RE: Percolation Test Report, Beaufort Park, Lots 10 and 12; A545133

SEWAGE DISPOSAL SYSTEM SPECIFICATIONS WORKSHEET

Subdivision: Beaufort Park Lot: 10

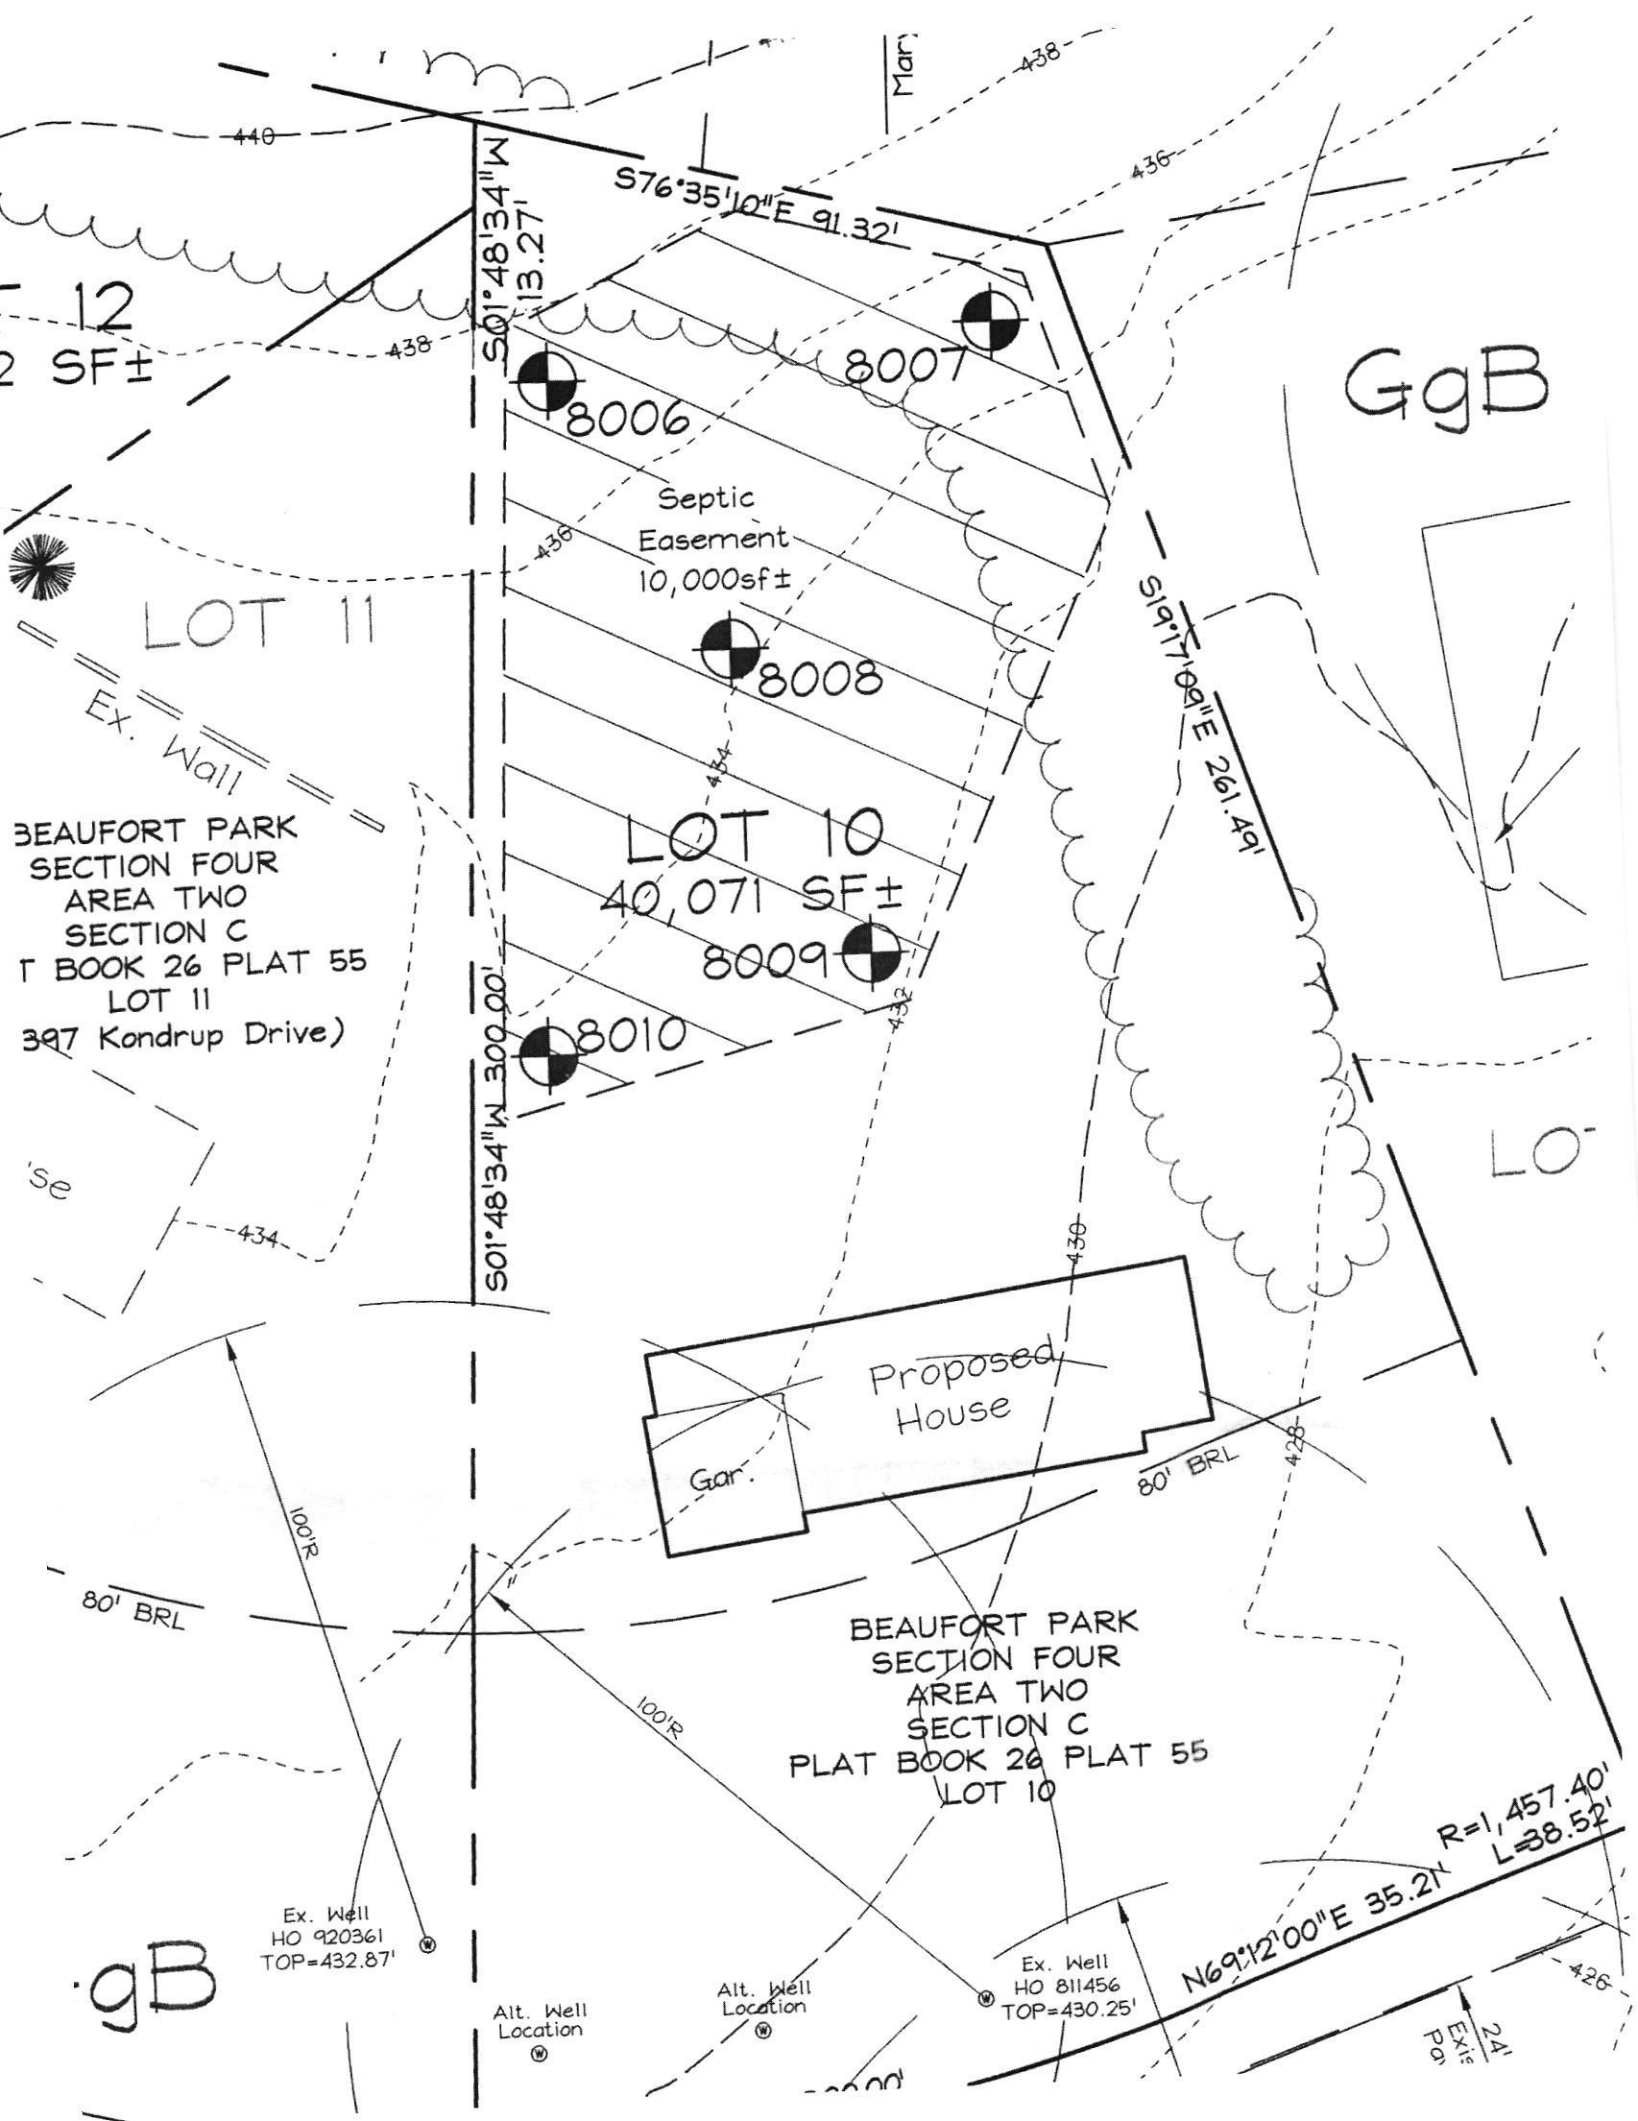
15. Any changes to private sewage disposal areas require a revised percolation certification plan.
16. An advanced pre-treatment system which utilizes Best available technology to pretreat sewage effluent shall be located on the septic system for lot 10 and 12. A supplemental plan with all necessary details for installation of the system will be required prior to release of building permits and septic system installation permits.

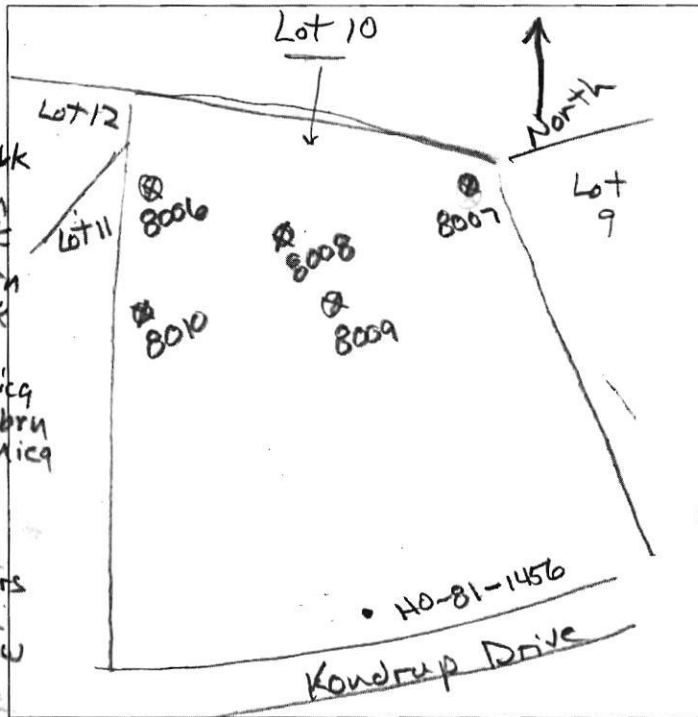
BAT unit required; Pump & Pump Tank
LPT design for drain field

*BAT requirement rescinded.
LPD drainfield design is optional.
Pump and Pump Tank are needed.*

28
7029
FIELD
SHEET

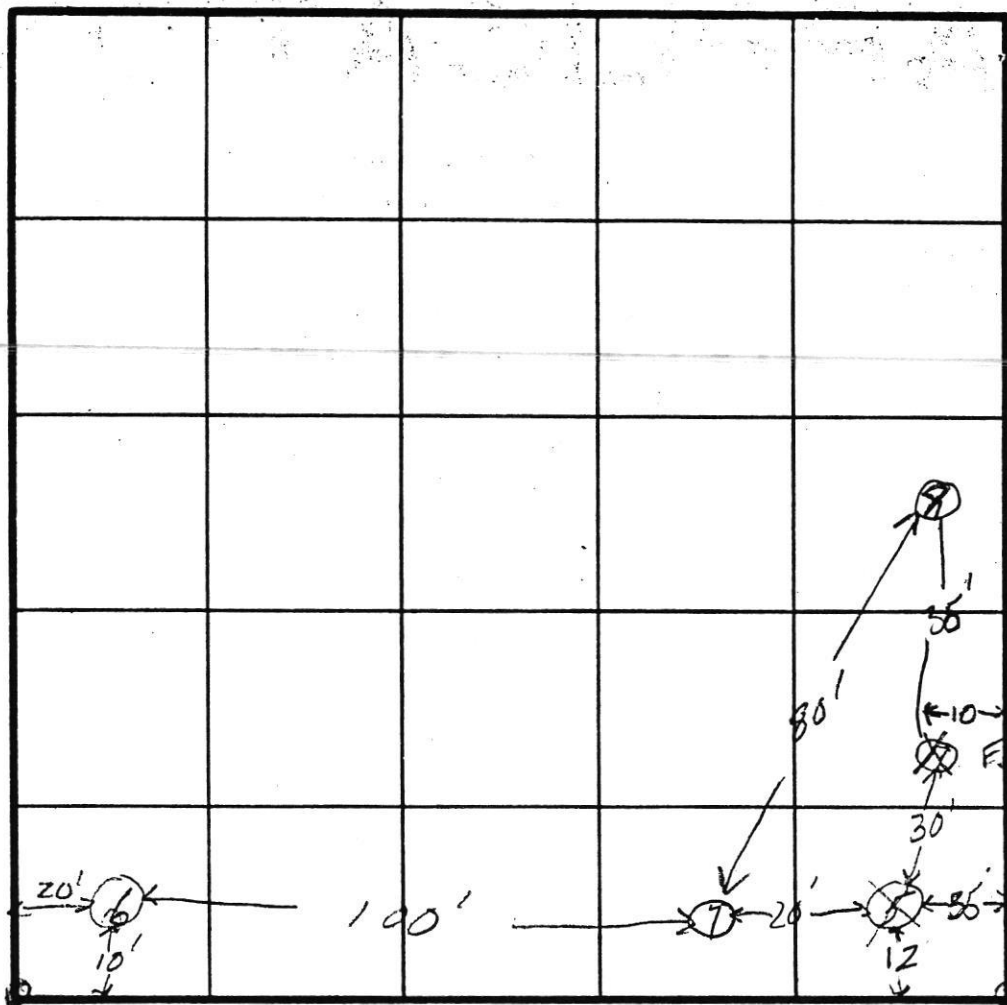
9-3-80 Hold for discussion with supervisor SK/

10-80 Move Sewage Permit 15' Towards front lot line as per
discussion with FF. SK/

HEAVY CLAY TO 7 1/2' IN RIGHT CORNER OF LOT
